SITE PLAN

for: A. D. SIDLEY INC CLIENT

26 SUBLOT No. WOODS OF CONCORD VOL. CONCORD PAGE
LOT, TRACT CONCORD OHIO

92-175

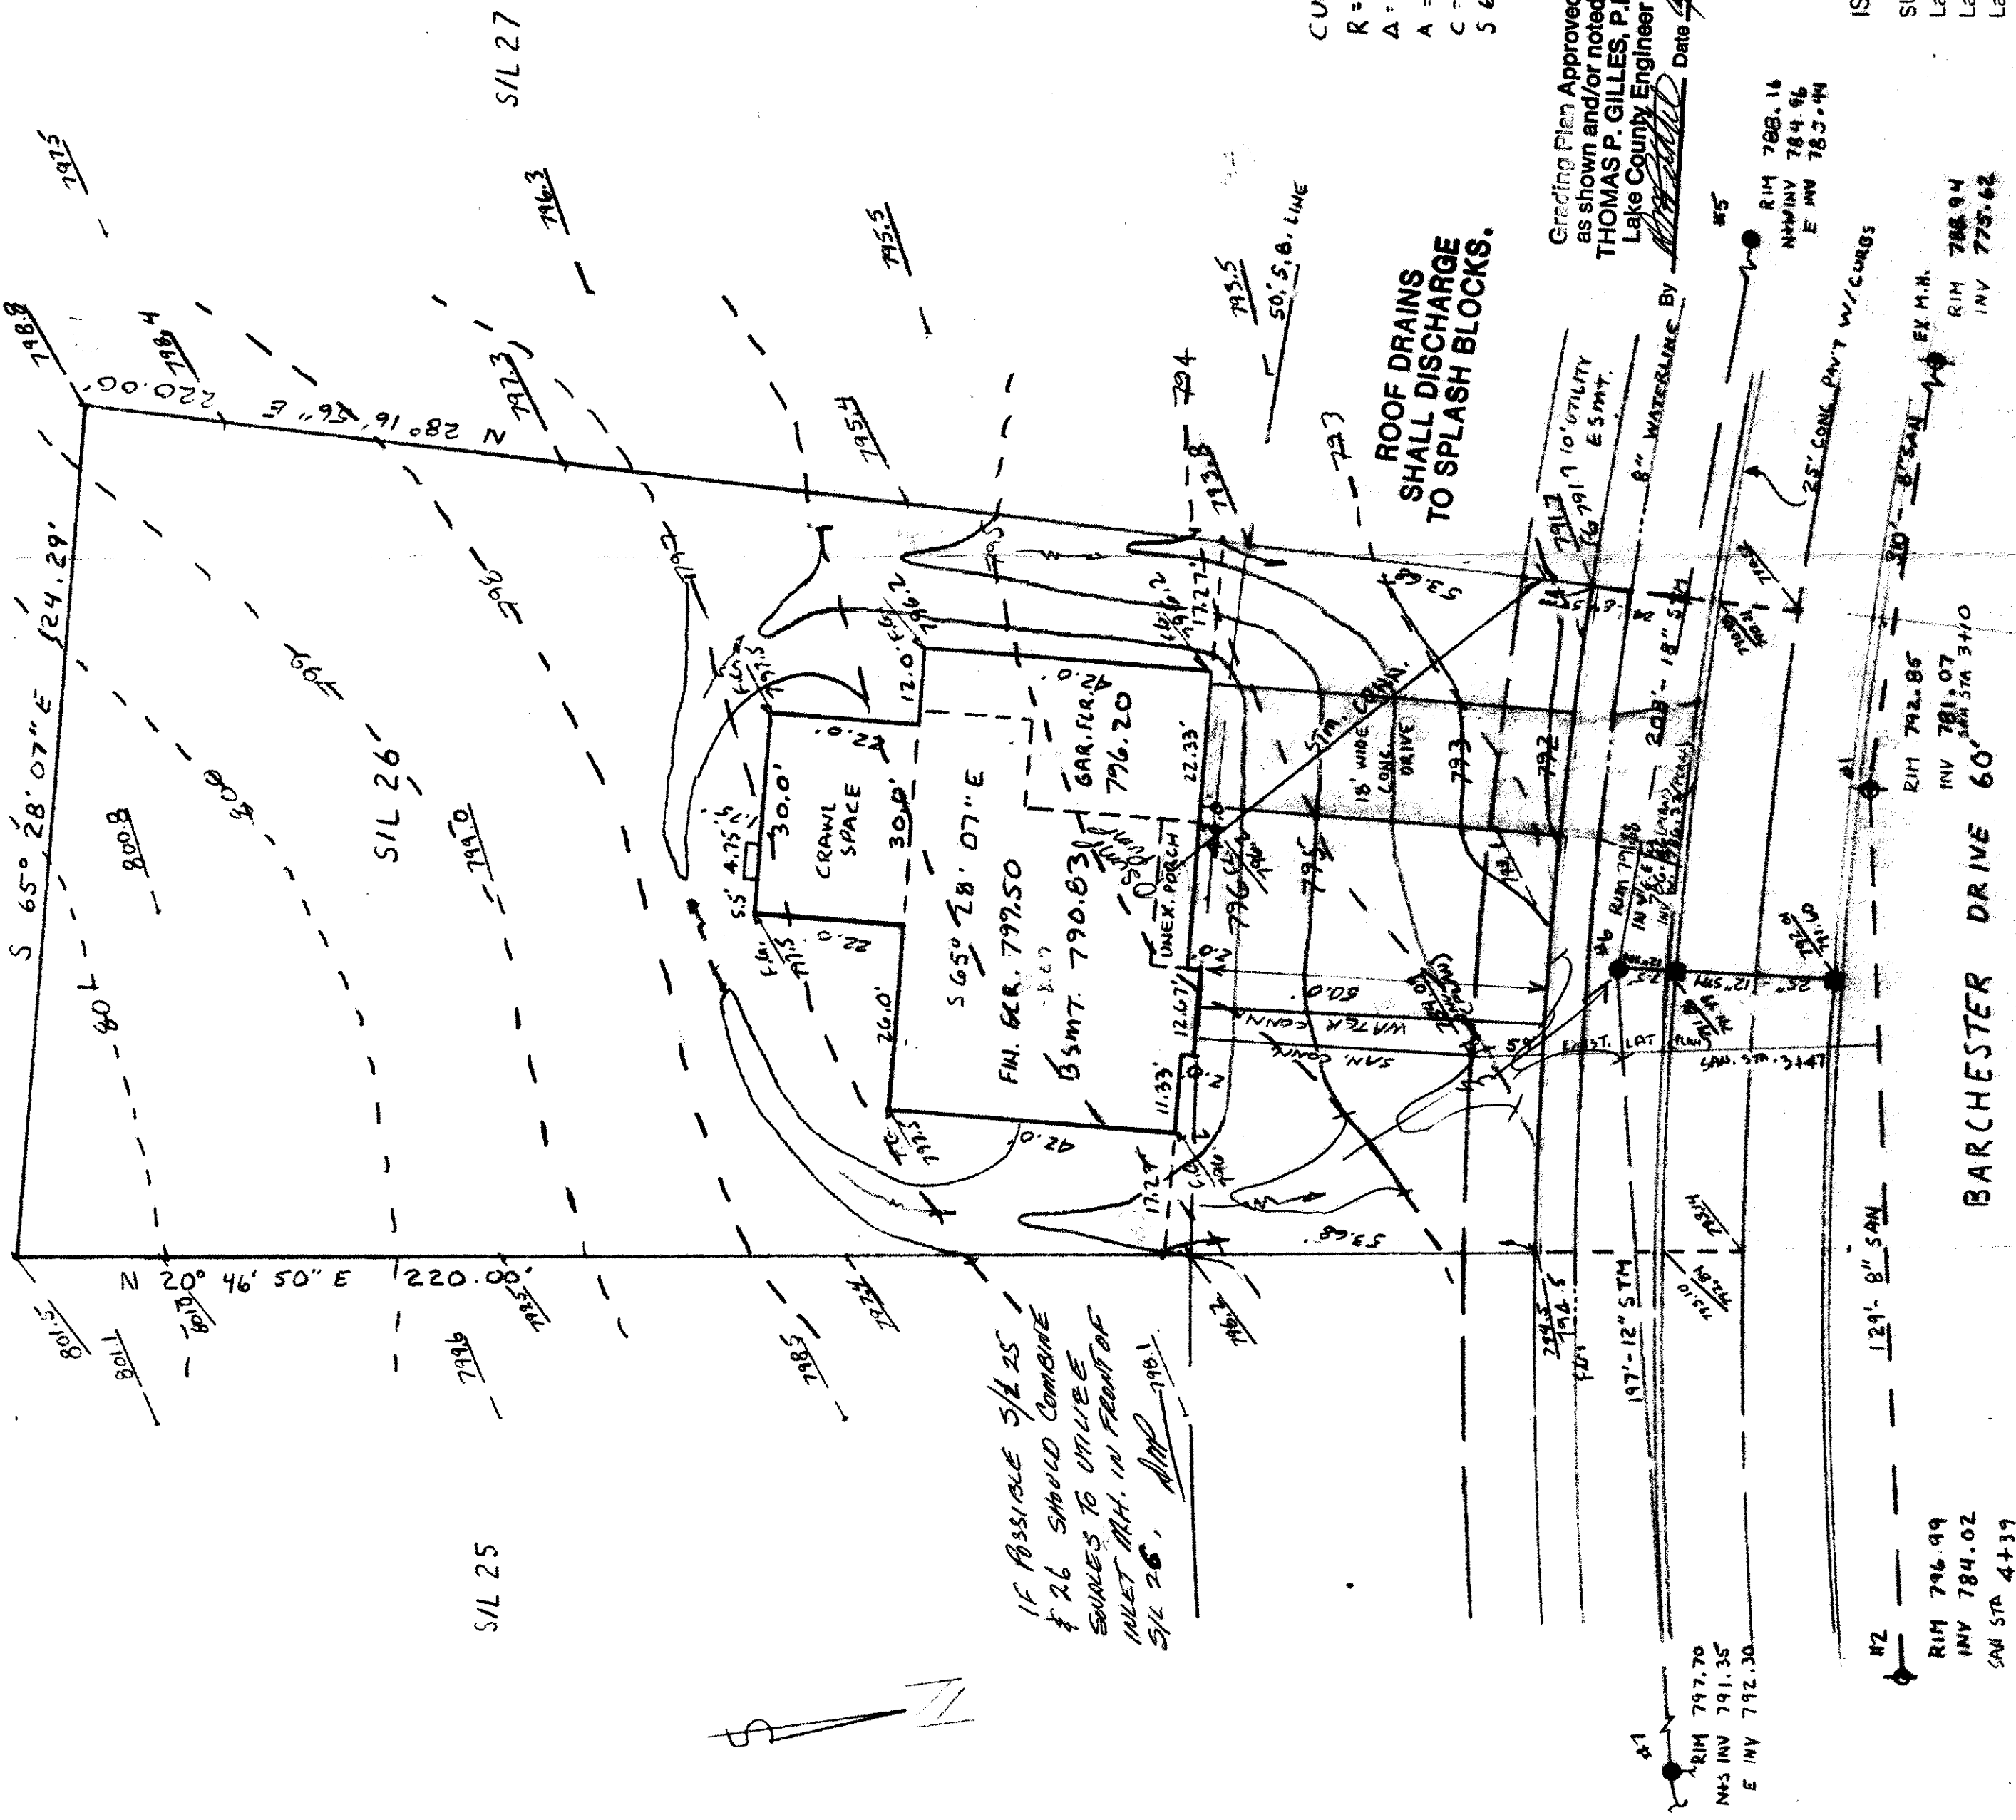
IF POSSIBLE 3/4 25'
#26 SHOULD COMBINE
SOURCES TO UNITE
INLET MH. IN FRONT OF
3/4 26'. APP. 199.1
